**PCN# 20181106001.1.A**  
**Qualification of TI Philippines as an additional**  
**Assembly and Test Site for select devices**  
**Change Notification / Sample Request**

**Date:** December 13, 2018  
**To:** Newark/Farnell PCN

<b>PCN Number:</b>	20181106001.1.A	<b>PCN Date:</b>	Dec 13, 2018
<b>Title:</b>	Qualification of TI Philippines as an additional Assembly and Test Site for select devices		
<b>Customer Contact:</b>	<a href="#">PCN Manager</a>	<b>Dept:</b>	Quality Services
<b>Proposed 1<sup>st</sup> Ship Date:</b>	Mar 07, 2019	<b>Estimated Sample Availability:</b>	Date Provided at Sample request
<b>Change Type:</b>			
<input checked="" type="checkbox"/>	Assembly Site	<input type="checkbox"/>	Design
<input type="checkbox"/>	Assembly Process	<input type="checkbox"/>	Data Sheet
<input checked="" type="checkbox"/>	Assembly Materials	<input type="checkbox"/>	Part number change
<input type="checkbox"/>	Mechanical Specification	<input checked="" type="checkbox"/>	Test Site
<input checked="" type="checkbox"/>	Packing/Shipping/Labeling	<input type="checkbox"/>	Test Process
<input type="checkbox"/>		<input type="checkbox"/>	Wafer Bump Site

Sample product shipping label (not actual product label)

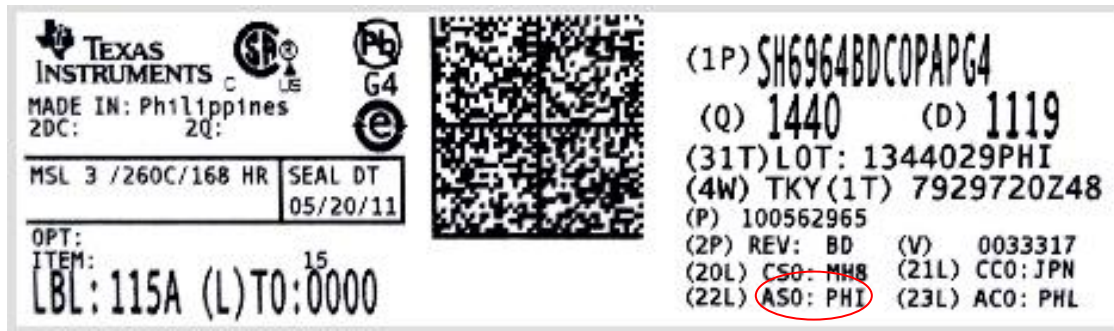
#### Changes to product identification resulting from this PCN:

Assembly Site		
Lingsen	Assembly Site Origin (22L)	ASO: LIN
<a href="#">TI Philippines</a>	Assembly Site Origin (22L)	ASO: <a href="#">PHI</a>
